CERTIFICATE OF APPROPRIATENESS

Property: 540 Columbia Street, Lot 22, Block 286, Houston Heights Subdivision. The property includes a historic 1,840 square foot, one-story wood frame single-family residence and a detached garage situated on a 6,600 square foot (50' x 132') interior lot.

Proposal: Alteration/Relocation – Resubmittal: At the November HAHC meeting, the applicant was denied an application to move the house 8' closer to the north property line, from current 10'-9" setback to 3'. Construct a 1,553 square foot addition and attached garage behind and on top of the rear 27.5% of the 1,840 square foot residence. The project also included the following alterations:

Recommendation: Denial - does not satisfy criteria

WEST ELEVATION – FRONT FACING COLUMBIA STREET

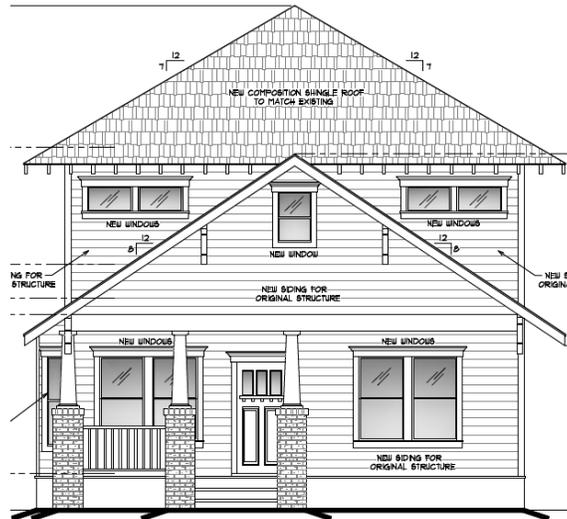
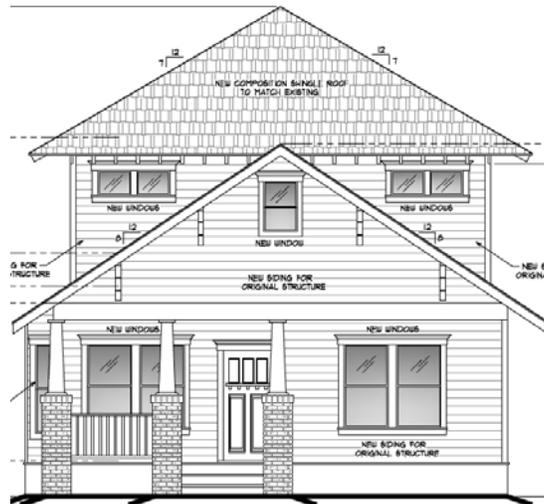
- (1) The proposed activity must retain and preserve the historical character of the property;
Although the project involves many positive alterations to return the house to a more appropriate historic character, beginning the second floor of the addition on top of the residence, 14'-7" forward of the original rear wall, and extending both side walls back on the first floor with no delineation between the original house and the addition on the north wall muddles the original form of the residence and damages its historic character. In addition, moving the house from 10'-9" to 3' of the north property line eliminates the historic context of the residence, which is currently centered on the lot. The current lot configuration is typical for the Heights and should be preserved.

- (4) The proposed activity must preserve the distinguishing qualities or character of the building, structure, object or site and its environment;
By beginning the second floor of the addition on top of the residence, 14'-7" forward of the original rear wall this proposal overwhelms the historic residence. In addition, moving the house from 10'-9" to 3' of the north property line eliminates the historic context of the residence which is currently centered on the lot.

NORTH SIDE ELEVATION

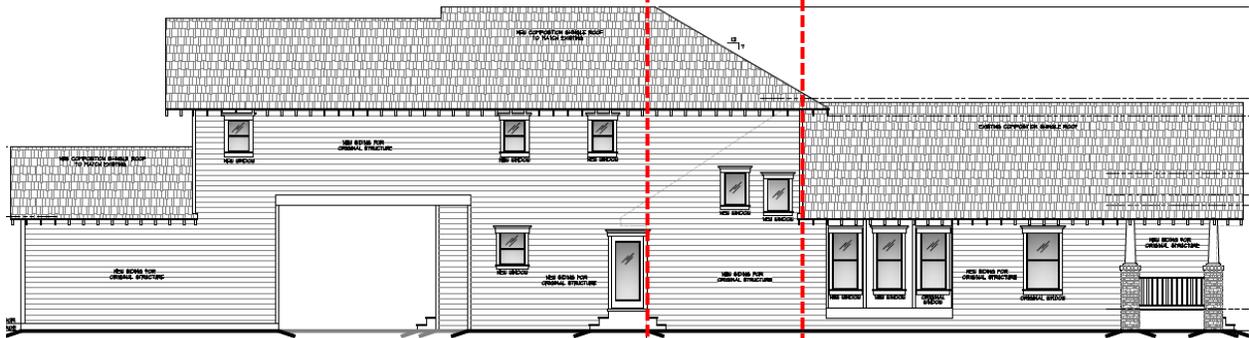
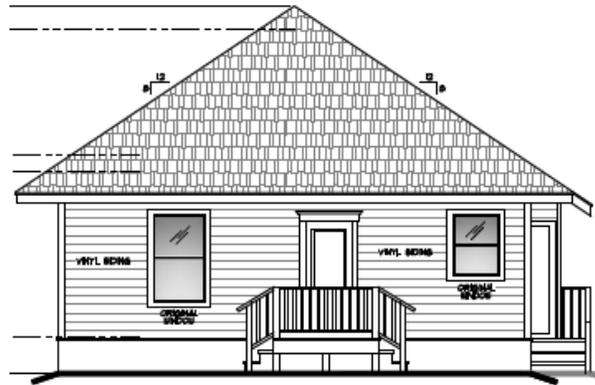
- (8) Proposed additions or alterations must be done in a manner that, if removed in the future, would leave unimpaired the essential form and integrity of the building, structure, object or site;
The proposed addition would be built on the rear 27.5% of the original house, which will impact a significant amount of the original structure and is essentially irreversible.

- (9) The proposed design for any exterior alterations or addition must not destroy significant historical, architectural or cultural material and must be compatible with the size, scale, material and character of the property and the area in which it is located;
Constructing the addition on top of the rear 27.5% of the original house overwhelms it. The removal of three original wood windows (out of eight remaining) and re-arrangement of window openings permanently removes significant historic material.

ORIGINAL WINDOWS TO BE REMOVED

NORTH WALL SIDING DETAILS

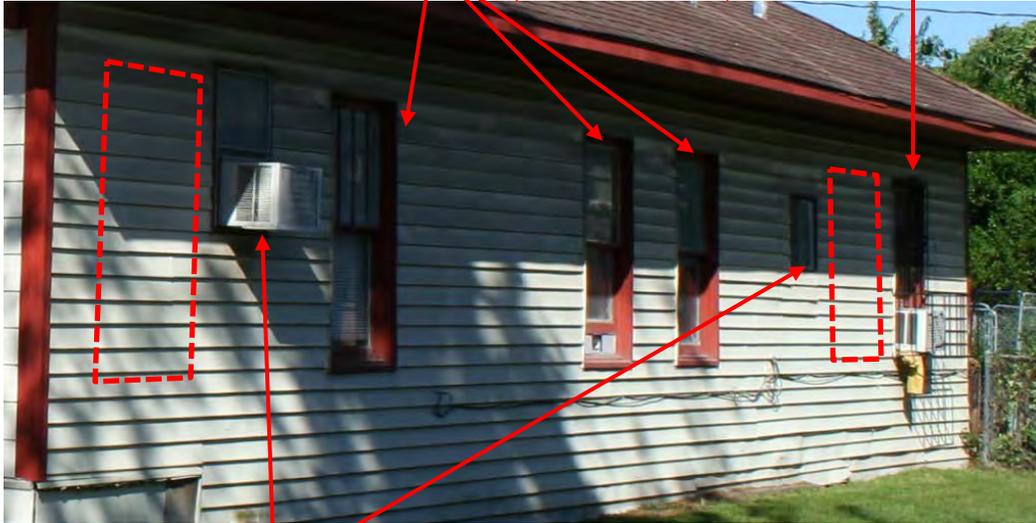
*ORIGINAL WINDOWS TO BE REMOVED
(SEE DETAIL BELOW)*

ORIGINAL WINDOWS TO BE REMOVED

SOUTH WALL

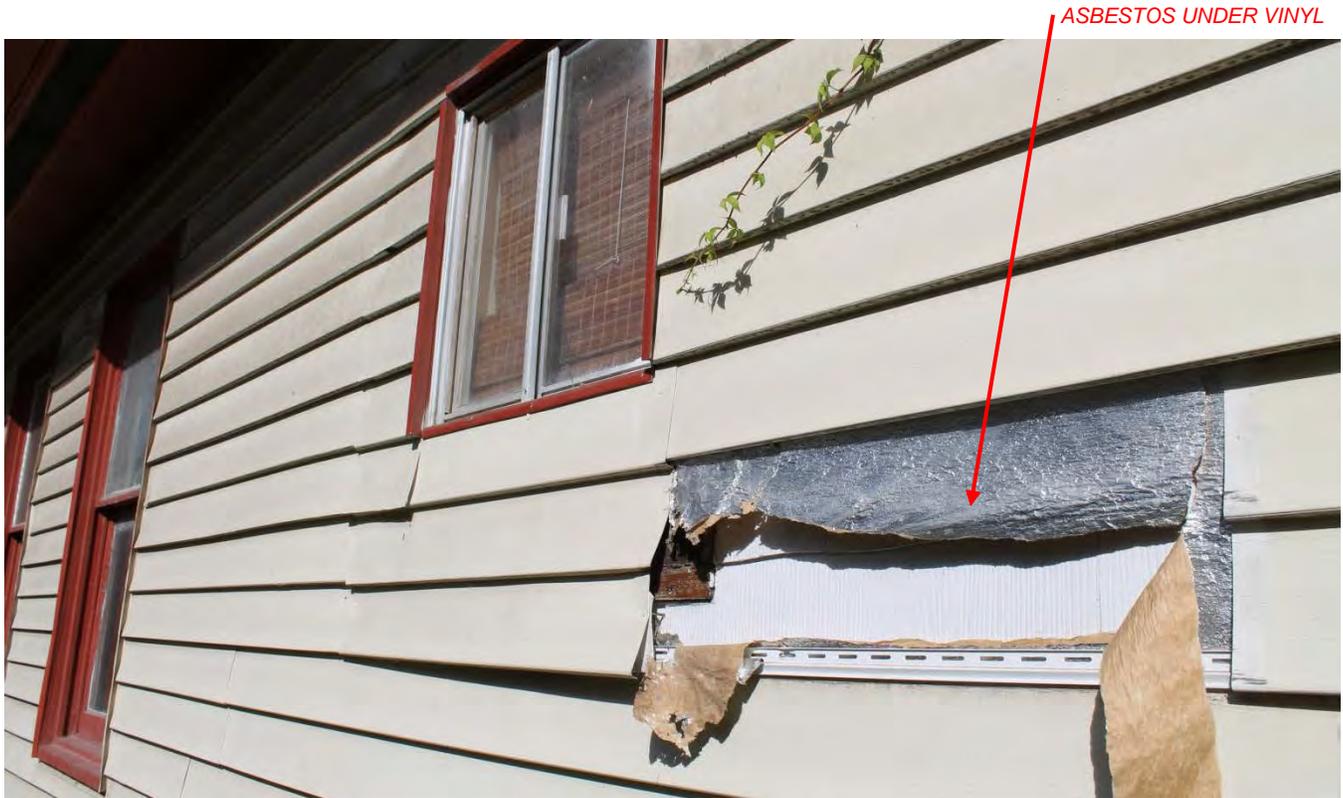
*ORIGINAL WINDOW TO BE REMOVED
(SEE DETAIL BELOW)*

PROPOSED NEW WINDOW OPENINGS

ROT IN SILL
